Agenda Item # 8

AGENDA REPORT SUMMARY

Meeting Date: April 28, 2017

Subject: 4880 El Camino Real—Elevator Tower Height Waiver

ELEVATOR SECTION
 1/4" = 1'-0"

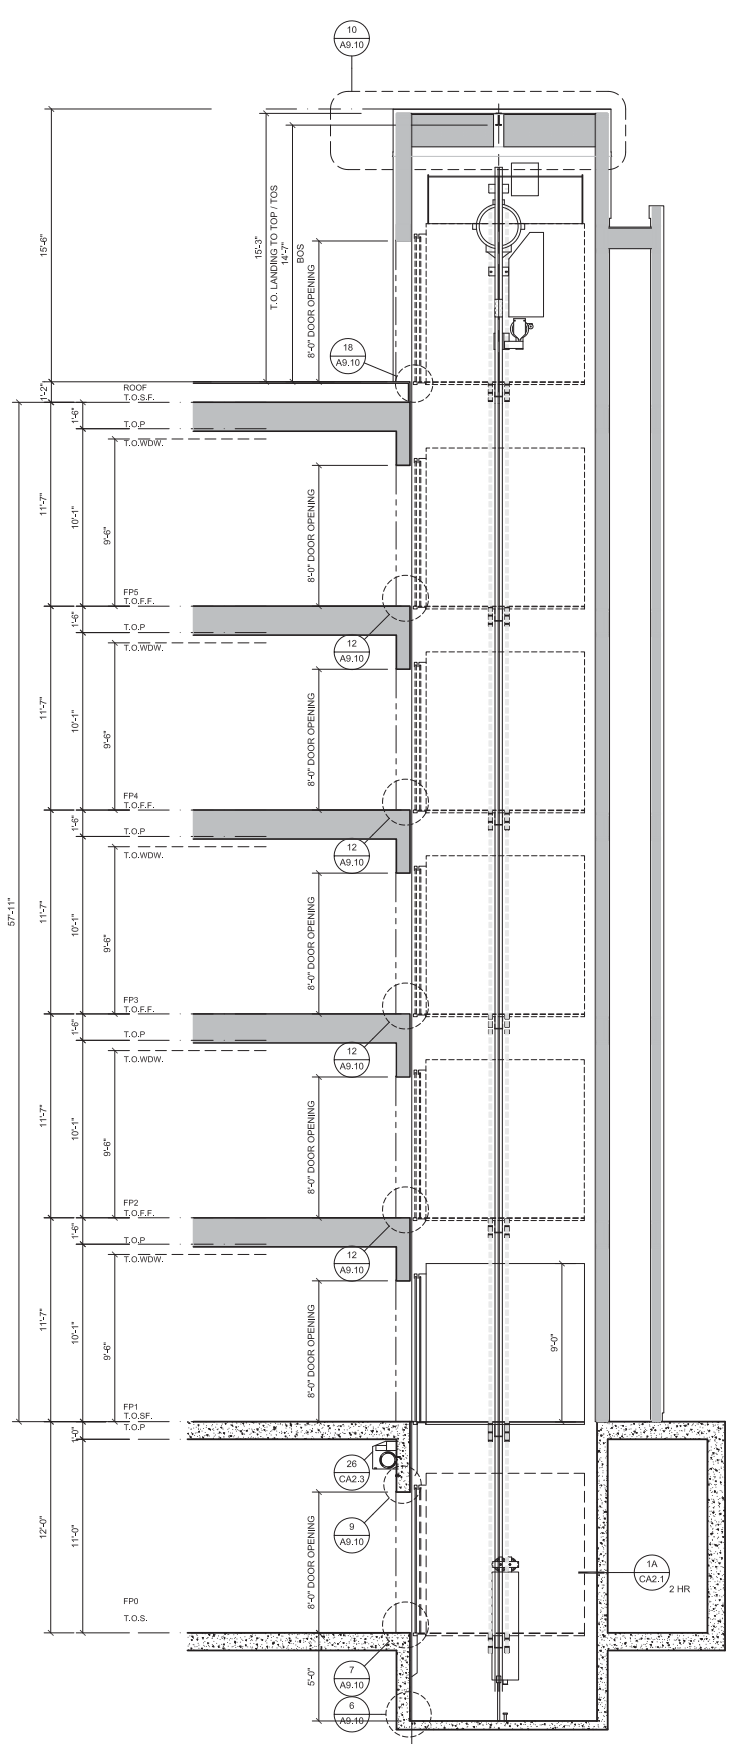
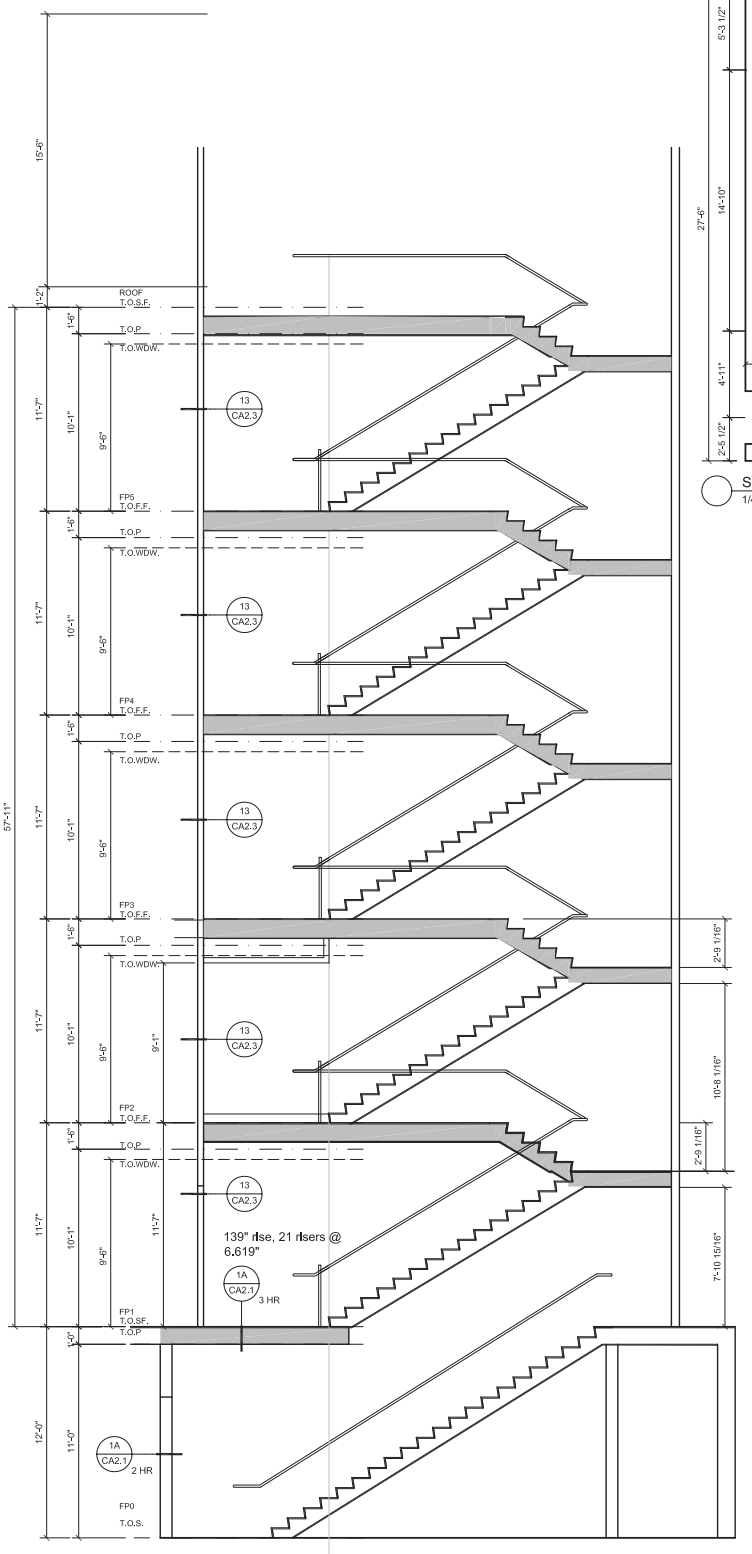
In developing the construction plans the project architect found it impossible to specify an appropriate elevator to serve the roof deck within the granted 11-foot height limit for its enclosure. The applicant desires a nine-foot tall elevator cab, which is commensurate with the taller ceilings. When considering the manufacturer's required structure above the elevator cab, the elevator tower enclosure must be a height of 15.5 above the roof (or 6.5 feet above the elevator cab). The project architect notes, but does not recommend, that the bare minimum would be an eight-foot-tall elevator cab, which would necessitate an enclosure height of 14.5 feet.

The project architect provided cross-sections of the elevator design (see Sheet A4.2 of the Plans) showing the minimal head space above the elevator cab dictating the overall elevator height of 15.5 feet. The project architect also provided three-dimensional graphics showing the effect of the 15.5-foot tall elevator tower. The graphics show that the taller elevator tower would be slightly visible from the street at more distant vantage points.

Move to approve Resolution No. 2017-14 allowing the elevator height to 15.5 feet above the roof but subject to keeping the overall height of the building at 69 feet.

Elevator tower

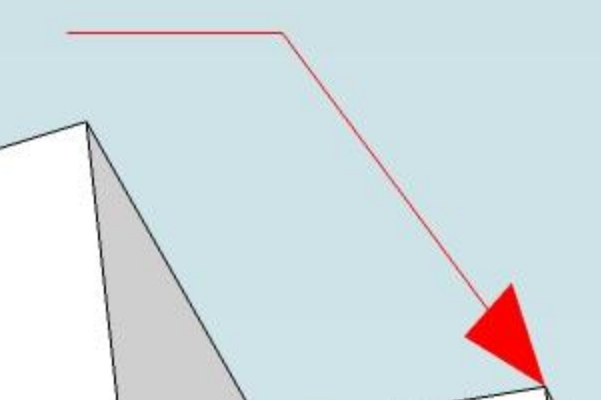
We also attach for your review some perspective studies showing what, if any, portion of the 15'-6" elevator shaft would be visible from several vantage points on El Camino Real. As you will see in the studies, the elevator shaft is hardly discernable given its location beyond the building's main facades. We believe that most people on the street will not be able to discern between a structure at 11 feet or at 15'-6".
